**CITY OF FERNDALE
WASTEWATER TREATMENT PLANT UPGRADE**

**ADDENDUM NO. 2 (55 pages total)
Issue Date: December 16, 2019**

2
S2.15
TYPICAL VIEW AT TOP OF SCREWS
NOT TO SCALE

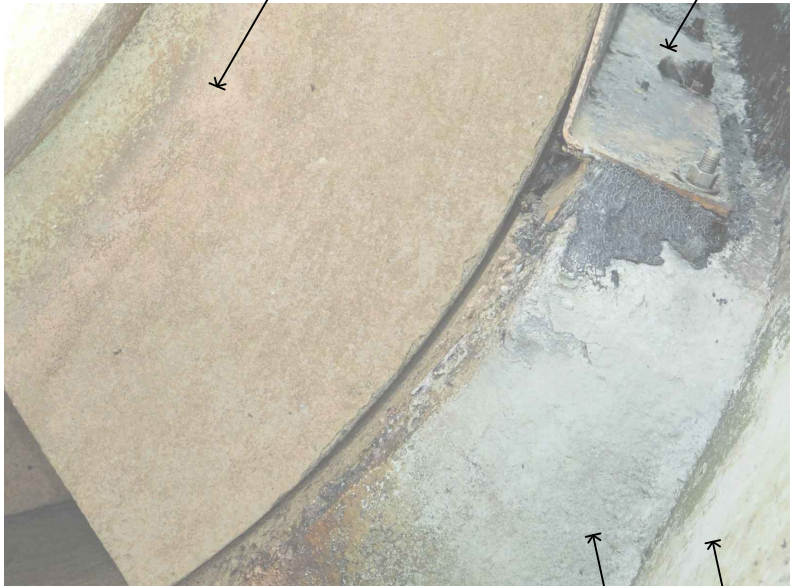
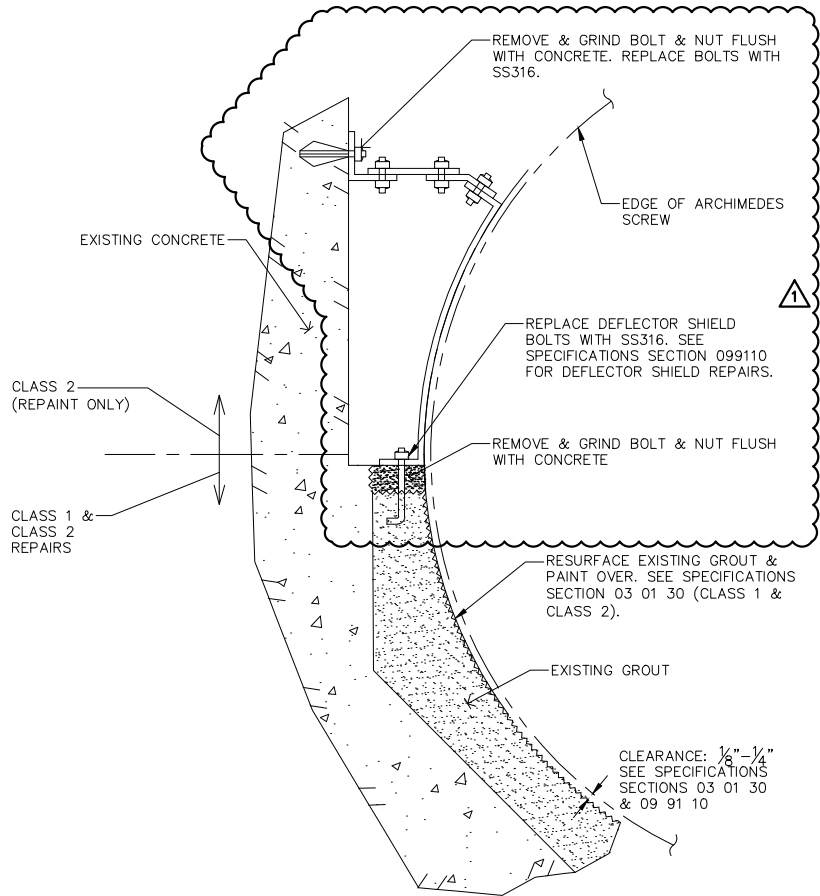
- **CLARIFICATION:** Diameter of existing screw pumps is 80-inches.
- **CLARIFICATION:** Contractor shall replace all bolts connecting the existing deflector shields to the concrete channels. Existing bolts shall be cut and ground flush with concrete. All new bolts and hardware shall be 316 stainless steel.
